Houston Lighting & Power South Texas Project Electric Generating Station P. O. Box 289 Wadsworth, Texas 77483

South Texas Project Electric Generating Station
Units 1 & 2
Docket No. STN 50-498, STN 50-499
Clarification to the Proposed Amendment to the
Unit 1 and Unit 2 Technical Specifications Regarding the
Spent Fuel Storage Pool Rack Criticality Analyses

**Safety Evaluation and No Significant Hazards Evaluation
for the
Spent Fuel Storage Pool Rack Criticality Analyses**

Figure 1 South Texas Region 1 Spent Fuel Storage Cell Nominal Dimensions

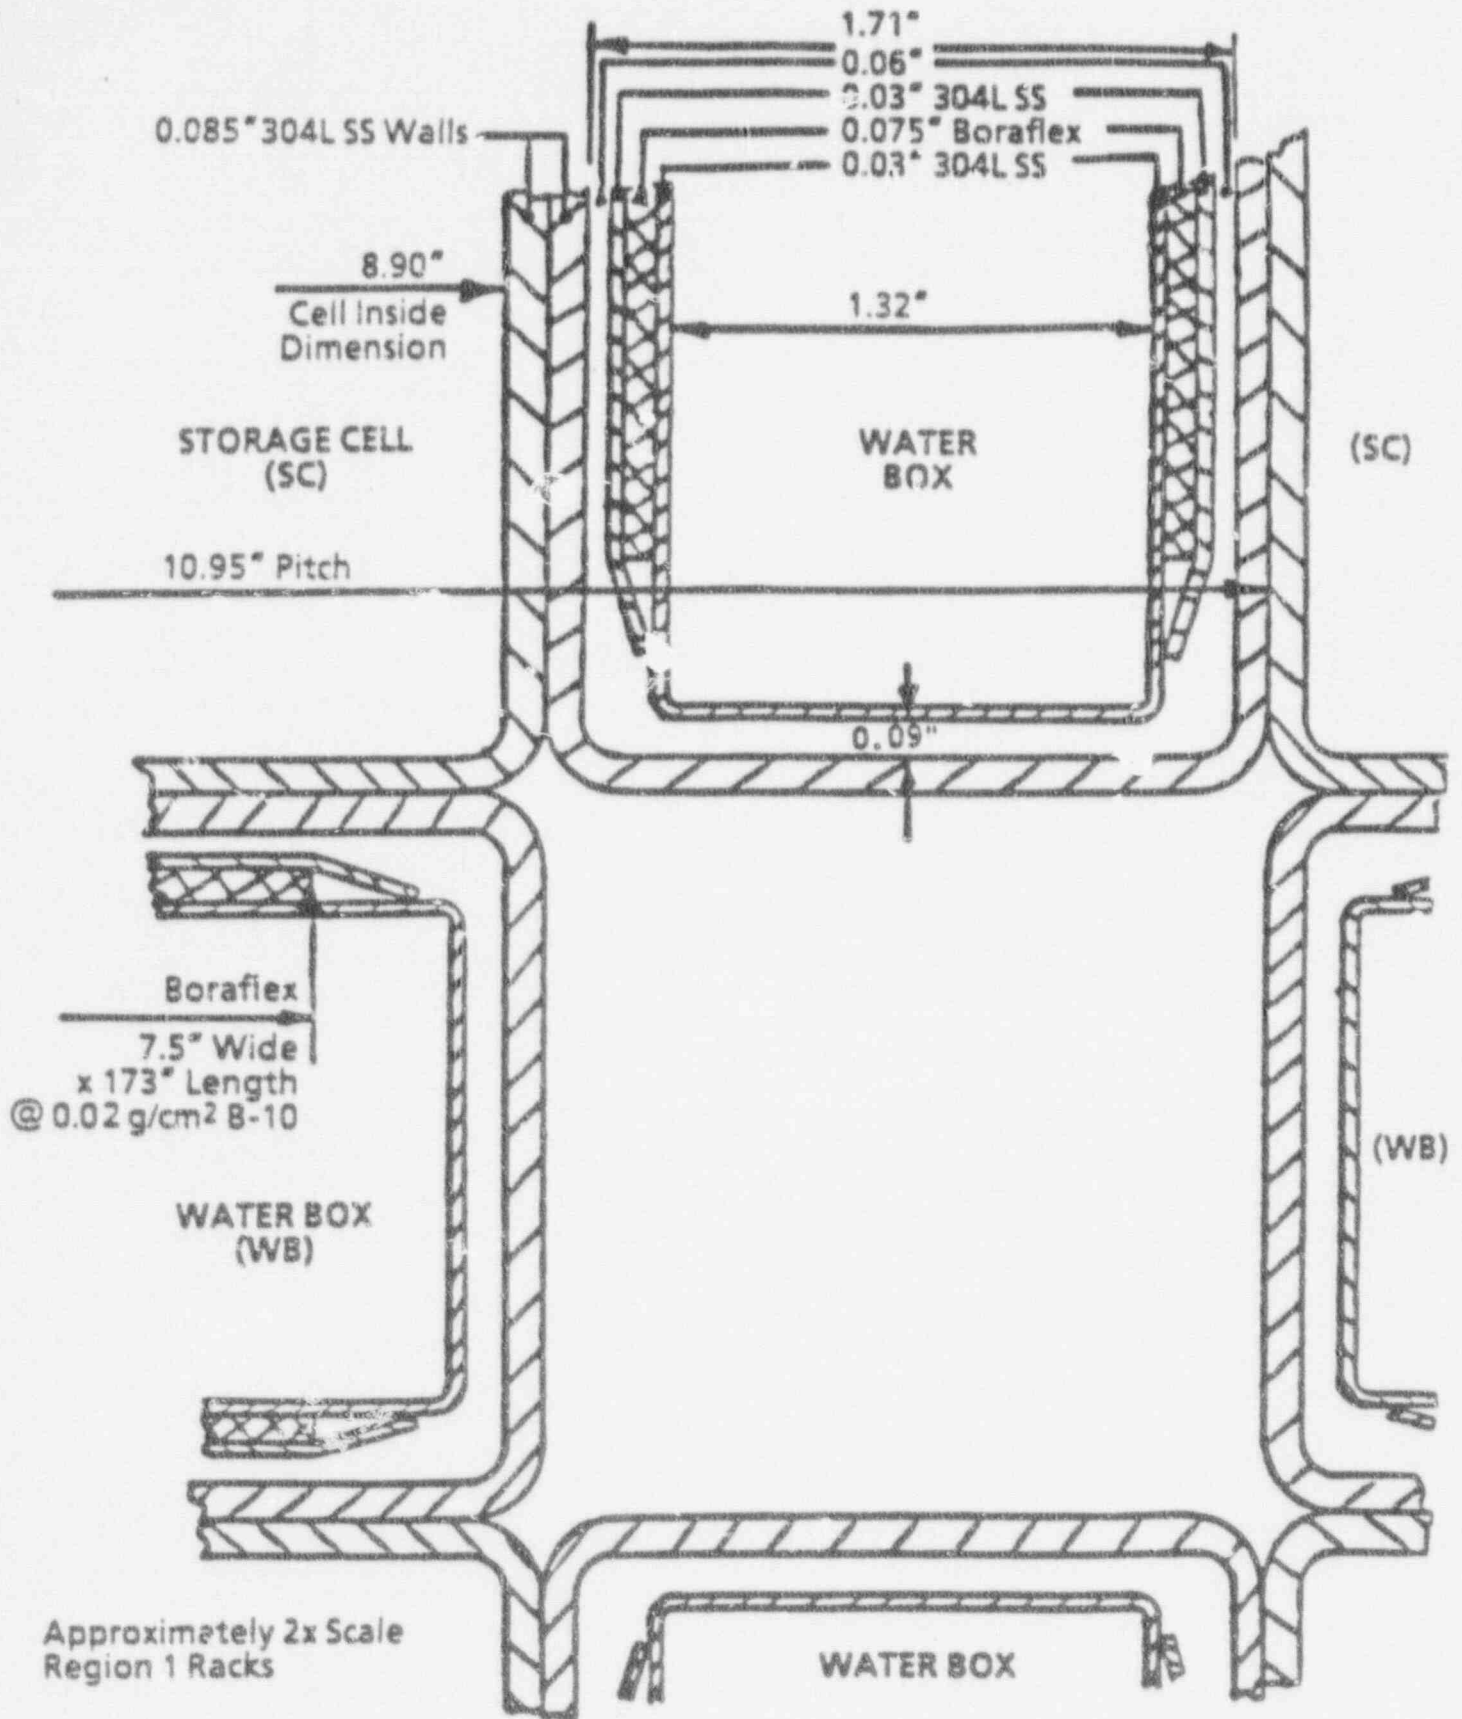
The attached pages reflect the requested changes (marked with
change bars) and editorial changes to figures 1, 2, 7, 9, and 11
of the Westinghouse criticality report.
